## 3.0L Engines with Blown Head Gasket

▲1997 3.0LX Sterndrive Engines: S/N 0K001529-0L000000.

1998 3.0L Sterndrive Engines: S/N 0L000001-0L097000.

**a** - Timing Mark At 1° ATDC (After Top Dead Center)

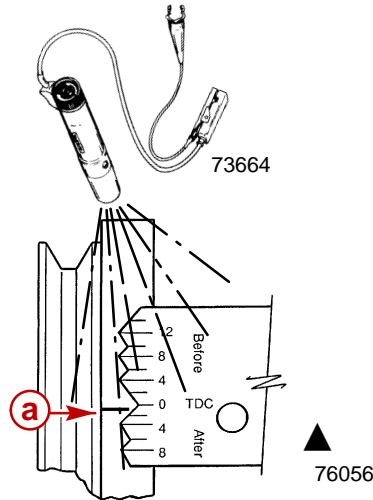
5. Reset repaired engine's initial timing to 1° ATDC.
